Consolidated questions for a correct understanding of the ongoing consultation on the redundancy of emergency services

[Raadpleging over een ontwerp van koninklijk besluit en van technische bijlage betreffende de invoering van het redundantiesysteem voor de nooddiensten | BIPT](#)

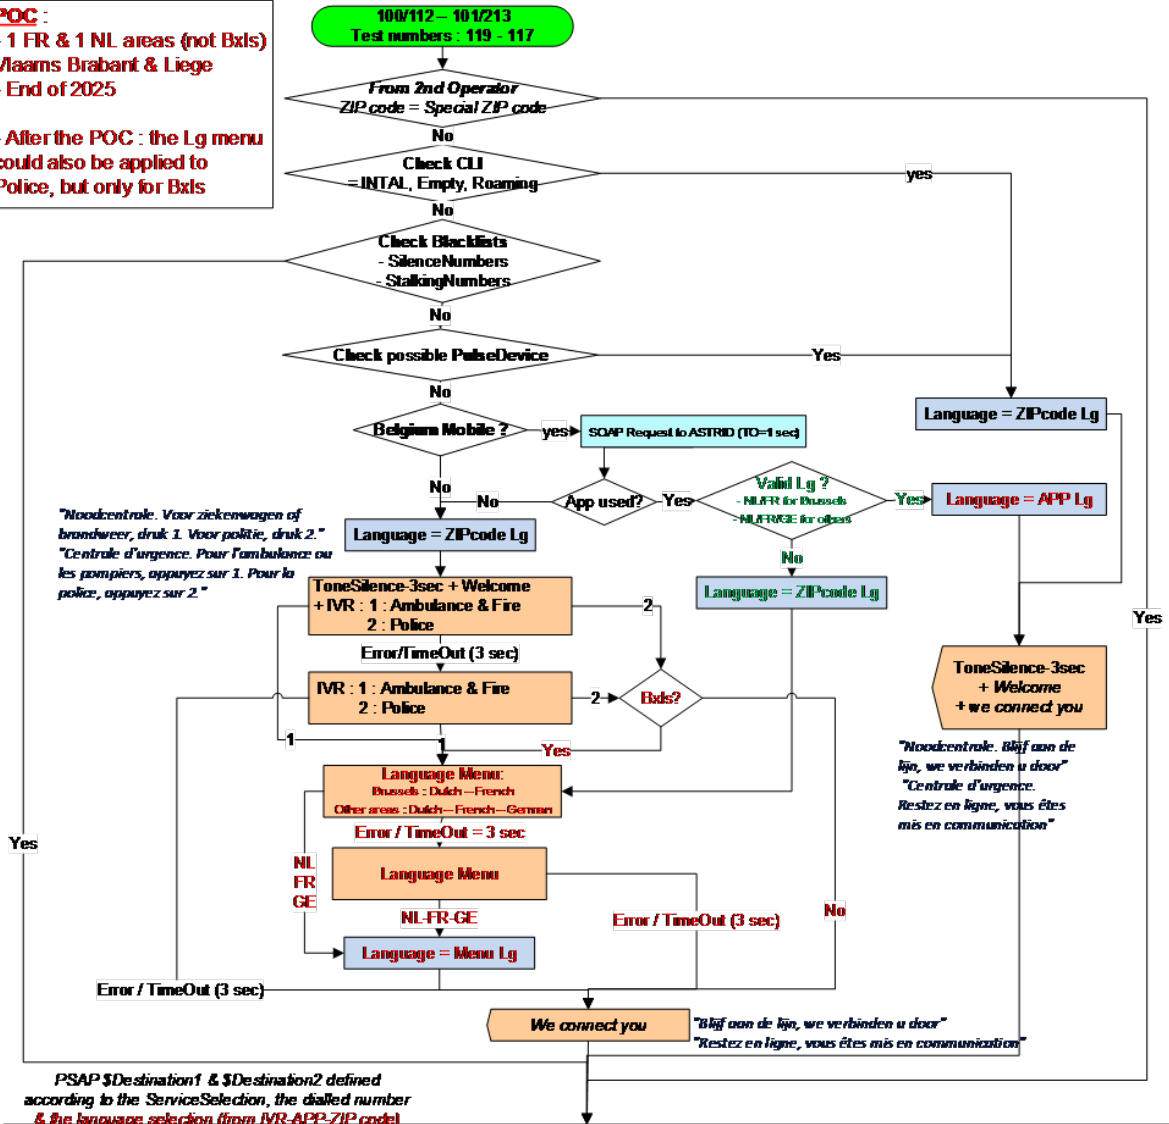
- *We request a more detailed description of the IVR call flow, including the main checks performed and a description of the SOAP interface.*

- *Please clarify what the "Check possible PulseDevice" step entails and what is required for this check.*

Answer: See previous question.

Answer: This step can be disregarded. Alternative operators generally no longer support pulse dialing.

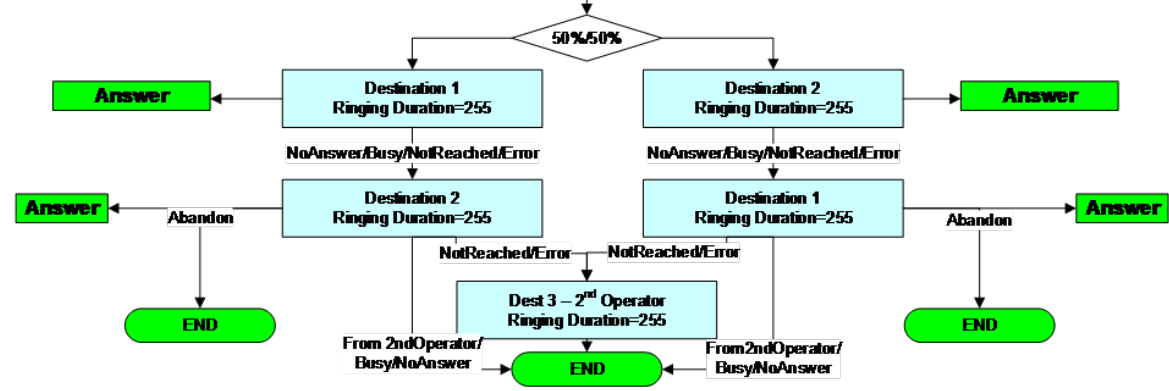
- *Astrid should deliver an updated IVR flow as this is not the latest version*

Answer: Cf. below.

POC :
 - 1 FR & 1 NL areas (not BxIs)
 Vlaams Brabant & Liege
 - End of 2025
 - After the POC : the Lg menu
 could also be applied to
 Police, but only for BxIs

PSAP \$Destination1 & \$Destination2 defined according to the ServiceSelection, the dialled number & the language selection (from IVR-APP-ZIP code)

Current Emergency Centers
 based on ZIP code and per ServiceNumbers (112/100/119 & 101/213/117)
For Ambulance/Fire, excepted BxIs :
 In case of APP-Lg or Menu-Lg ⇔ ZIP-Lg, then new destinations are foresee** excepted for 117/119 ServiceNumber & Telcel destination.
 ** New dest. based on the APP or Menu Language : 112GE - 112FR - 112NL
For Brussels (Ambulance/Fire or Police) : ZIP (native) language is Bilingual.
 In case of Valid APP-Lg or Menu-Lg (FR or NL), new dest is used : 112BxIsNL - 112BxIsFR - 101BxIsFR - 101BxIsNL

*In case of unknown ZIP code (UDOC) :
 GE-FR-NL new areas will be used
 (and not BxIs FR/NL)*
